Project Highgate Mallinson Sports Centre
Project No. 3244
Subject Basement Extent Change Review
Client Highgate School

Document Reference	Status	Revision	Issued	Checked	Approved	Date
3244-A2S-XX-XX-TN-Y-0002-00	First Issue	00	Paul Smith BEng(Hons), MSc DIC, CEng Associate Director	Qi Cheng Sia MEng(Hons) Senior Engineer	Alex Nikolic BEng(Hons), MSc DIC, CEng Director	11/02/2025

Figure 2.3 Comparative section view of current proposals (right) and submitted proposals (left)

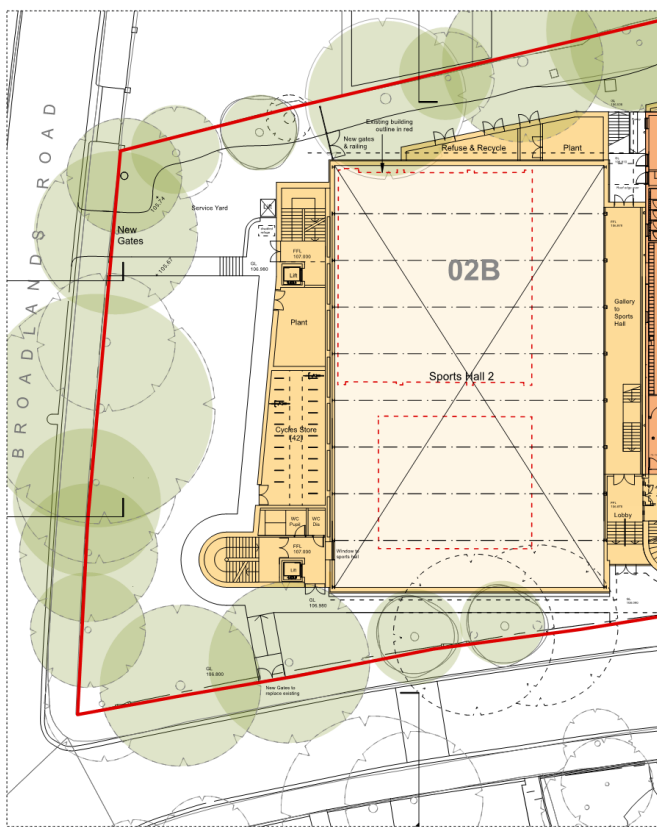
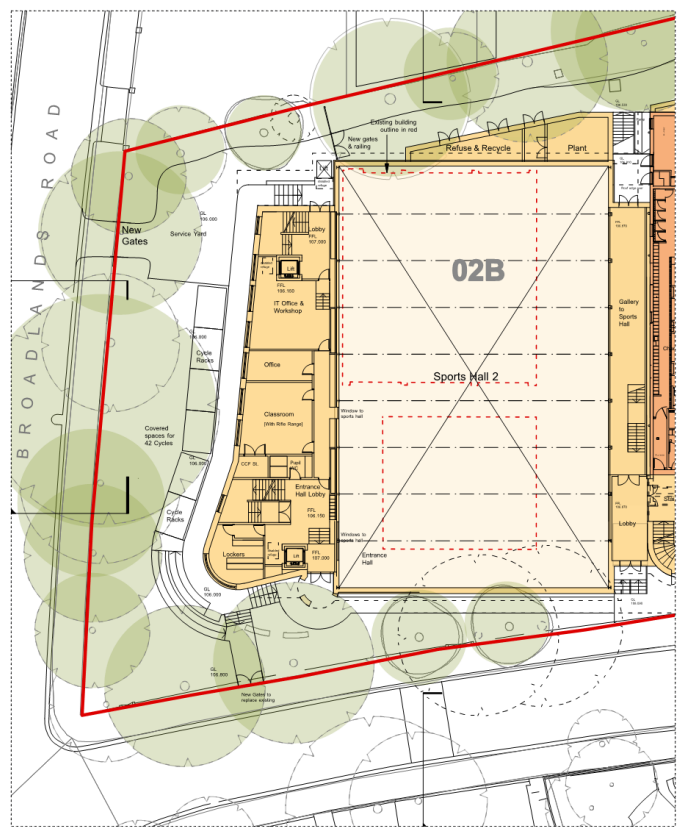
It is understood that the proposed scheme changes are limited to a reduction in basement footprint for the North Block on the north side of the new sports hall – refer to Figure 2.2 & Figure 2.3.

- The basement area is being reduced, not increased.
- The basement depth, has been retained at the same level and has not been deepened.
- At the time of writing this note it is considered that there are no other aspects of these proposed scheme amendments of relevance to the conclusions of the BIA.
